SUBJECT: PALO VERDE NUCLEAR GENERATING STATION, UNIT 3 – RELIEF
REQUEST 54 TO APPROVE AN ALTERNATIVE TO FLAW REMOVAL FOR
REACTOR COOLANT PUMP 2A SUCTION PRESSURE INSTRUMENT
NOZZLE (CAC NO. MF6806)

SAFETY EVALUATION BY THE OFFICE OF NUCLEAR REACTOR REGULATION
RELIEF REQUEST 54 REGARDING PROPOSED ALTERNATIVE FOR REPAIR OF
INSTRUMENT NOZZLE AT REACTOR COOLANT PUMP 2A
ARIZONA PUBLIC SERVICE COMPANY
PALO VERDE NUCLEAR GENERATING STATION, UNIT 3
DOCKET NO. 50-530

Figure 1-1. RCP 2A Instrumentation Nozzle Repair Schematic

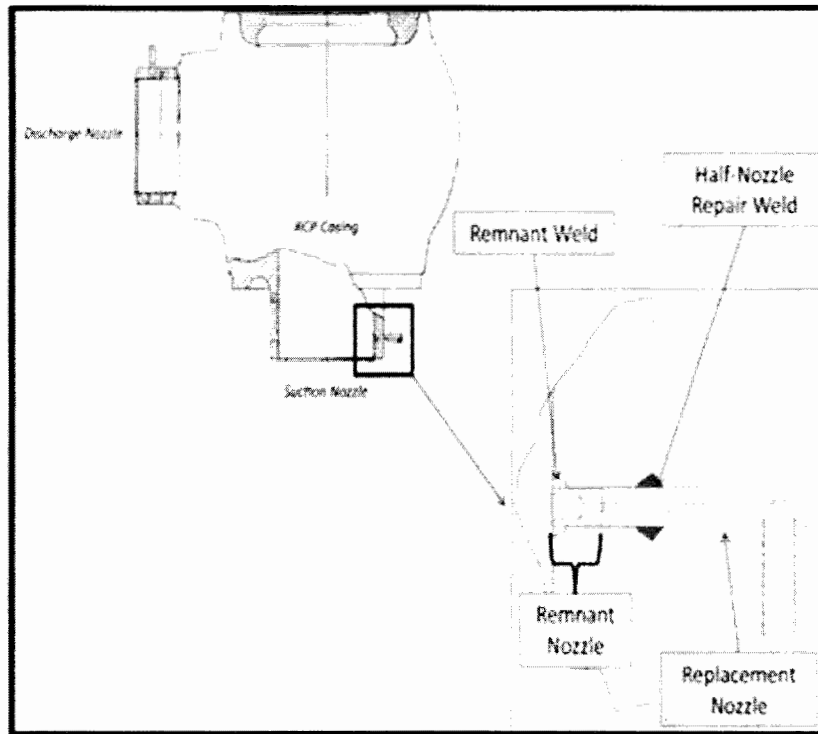
During the 3R18 spring 2015 refueling outage at PVNGS, Unit 3, the licensee performed a half-nozzle repair of the RCP suction safe end Alloy 600 instrument nozzle due to leakage in the annulus between the outer surface of the instrument nozzle and the bore on the suction safe end. The Alloy 600 instrument nozzle is attached with a partial penetration weld to the inside of the RCP suction safe end using Alloy 82/182 weld filler metal. The licensee stated that the most likely location of the flaw(s) that caused the leakage is in the PWSCC-susceptible Alloy 82/182 weld and the Alloy 600 instrument nozzle, along their fusion line inside the safe end bore. The half-nozzle repair entailed severing the instrument nozzle on the outside of the RCP suction safe end, followed by machining out a portion of the nozzle inside the bore. The removed portion of the Alloy 600 instrument nozzle was then replaced with a section (half-nozzle) of more PWSCC-resistant Alloy 690 material which was welded to the outside surface of the suction safe end using Alloy 52M weld filler material. A small gap is left between the new Alloy 690 replacement nozzle and the remaining Alloy 600 nozzle which allows reactor coolant to enter the crevice region between the carbon steel (SA-508, Class 1) RCP suction safe end material, Alloy 690 replacement nozzle and the remaining Alloy 600 nozzle material. A schematic of the repair is provided Figure 1-1 below. The licensee stated that half-nozzle repairs have been successfully implemented on 73 Alloy 600 small-bore RCS hot-leg nozzles.

The NRC staff finds that the licensee has analyzed the stresses in the RCP suction nozzle safe end, the remnant nozzle, weld, half-nozzle replacement nozzle, and the half-nozzle repair weld in accordance with the ASME Code, Section III. The NRC staff finds that the stresses of these components satisfy the allowable stresses of the ASME Code, Section III and, therefore, are acceptable.
